MEMORANDUM

SUBJECT: **Hearing** Report - ZC #14-18 (Brookland Manor)
First Stage and PUD and Related Map Amendment

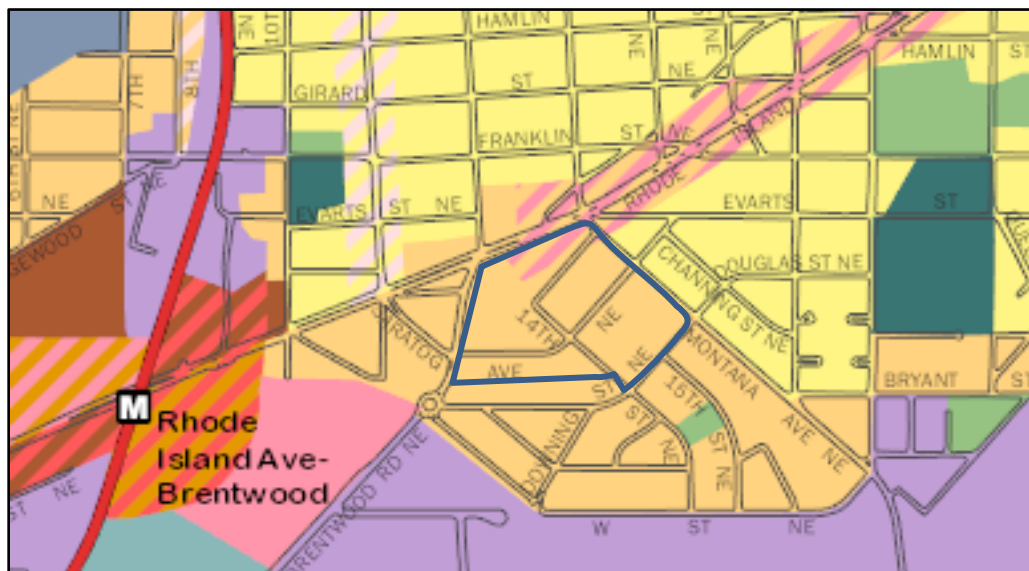
The proposed C-2-B/PUD introduces density and heights that are greater than those recommended under moderate density. The proposed C-2-B and C-2-A mixed use buildings within the PUD extend commercial uses well into the residential designated area and are also difficult to rectify with the existing classification of Neighborhood Conservation Area which in this case is residential use.

The illustration below shows the proposed development with the existing mixed use moderate density designation of the FLUM superimposed. All other areas of the site are designated moderate density residential. Proposed maximum building heights are noted.

There is no land use supplemental guidance for this site and although the PUD would further many of the Comprehensive Plan goals for revitalizing neighborhoods, improving housing quality and transit oriented development, the Comprehensive Plan Land Use and Policy maps designate such redevelopment at a lower density and height than proposed in this application. The Comprehensive Plan maps are generalized and show general patterns of development appropriate for an area, not for individual property boundaries, and OP does not disagree that the site is appropriate for an increase in density beyond that of the Comprehensive Plan maps. However, it appears that the Comprehensive Plan should be changed first, before the proposed zoning can be determined fully “not inconsistent.”

Map 5 – Proposed Zoning

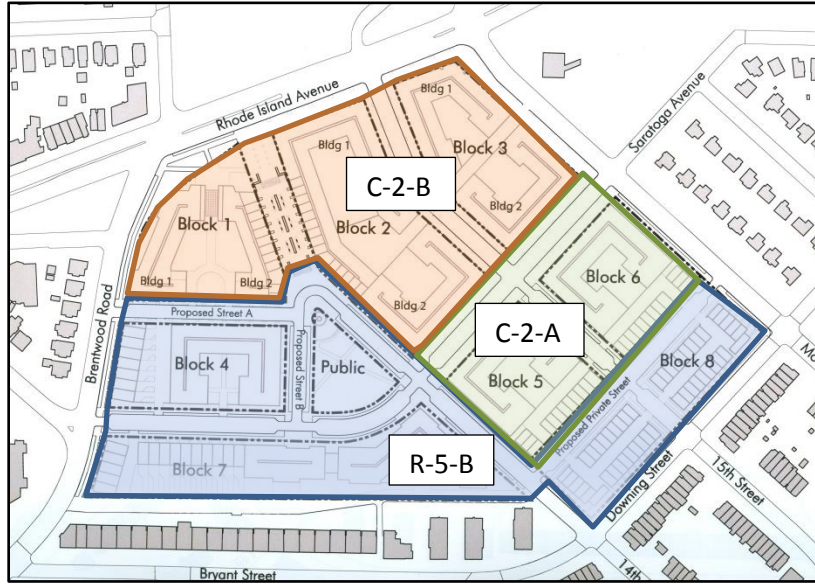
As shown on the map below, the applicant has requested the following PUD-related map amendments:

- Blocks 1, 2 and 3, planned for the mixed use buildings with retail and apartment uses in the C-2-B zone;
- Blocks 5 and 6, planned for mixed use buildings with retail, apartments and rowhouses and would be in the C-2-A zone; and

- Blocks 4, 7, and 8, planned for a mix of apartments and rowhouses and flats in the R-5-B zone.
